80 Kinloch Court, Craigieburn

Permit No. PA2403014

Planning Permit Officer Assessment
(Clause 53.22)

Officer Assessment Report
Development Approvals & Design

Figure 14: Site security requirements

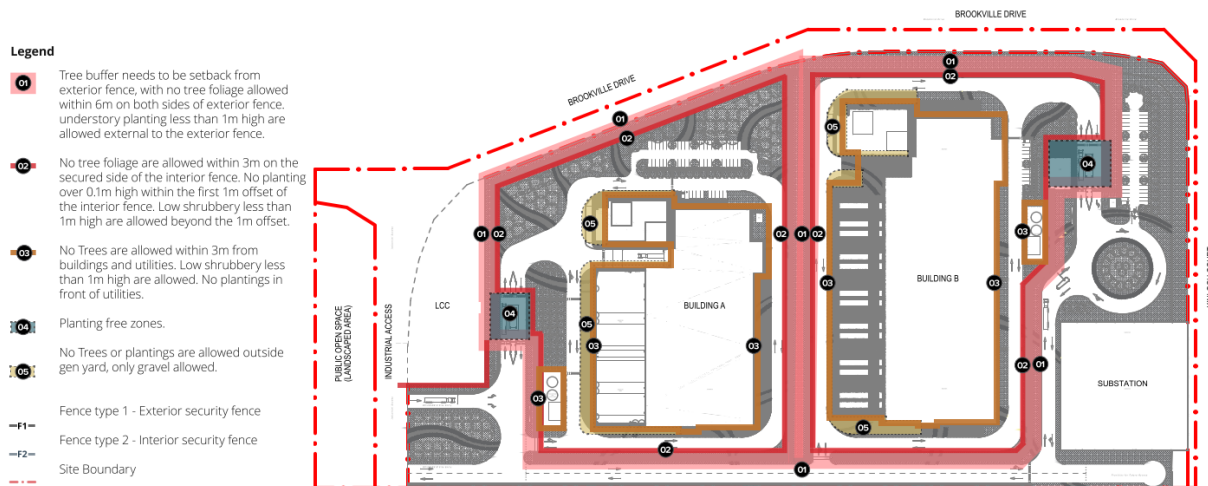
156. Due to the nature of the proposed use, the applicant has provided a security requirements plan. In particular, the plan identifies that no tree foliage within 6m of the exterior security fence and that understory planting within the buffer area must be no greater than 1m high (see Figure 14).
157. The extent of the proposed landscaping is discussed in greater detail below, however the submitted landscaping plan indicates that planting will be provided with the setback to the western boundary comprising of 'Planting Mix D' consisting of site peripheral plantings including predominantly low ground cover plantings to meet the security needs.

158. While the security requirements do conflict with the requirements and guidelines of the Craigieburn North Employment Area PSP, these requirements must be balanced with the nature of the nature of the proposed land use. Noting the setback between the perimeter security fence to the approved line of subdivision boundary is approximately 11 m, there is capacity to comply with the security buffer area requirements and accommodate for more appropriate screening (through vegetation) beyond 6m from the security fence along the western interface to soften the appearance of the development.

Figure 19: Alternative site drainage layout (Source: Stormwater Management Strategy and Stormwater Management Plan)

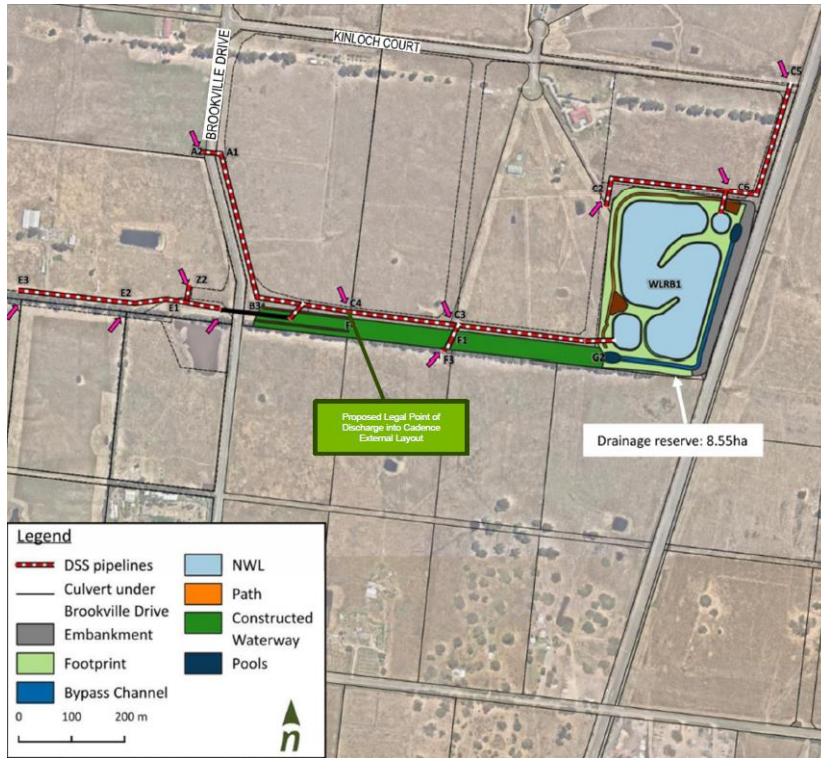
242. The SWMS sets out an alternative Brookville Drive DSS layout (see Figure 19 for DSS layout) to provide a more efficient design system that meets Melbourne Waters requirements and details the proposed drainage system, proposed water corridor, proposed stormwater quality treatment system and interim conditions should development of subject site occur prior to the delivery of drainage infrastructure.

Figure 20: Proposed temporary site drainage layout with retarding basin (Source: Stormwater Management Strategy)

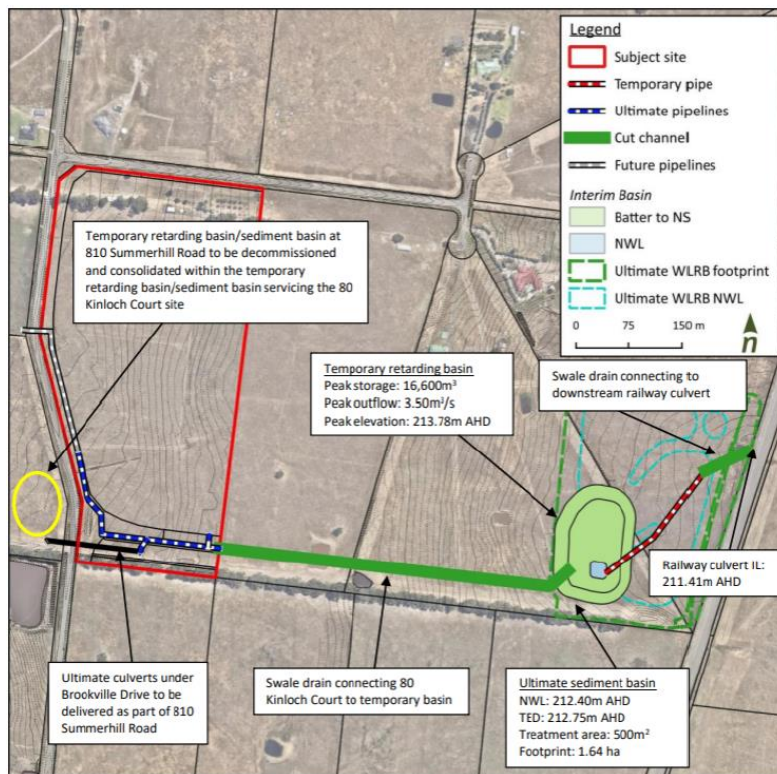
247. Further, an interim site drainage layout is detailed to facilitate the development of the subject site prior to the delivery of necessary drainage infrastructure which includes the construction of a retarding basin at 810 Summerhill Road adjacent to the site (south-west) of which is owned by the owners of the subject site (Figure 20). The SMP also details the proposed stormwater layout throughout the development site (Figure 21) with the legal point of discharge within the south-east corner of the development site which connects to the broader stormwater network detailed above within the SWMS.
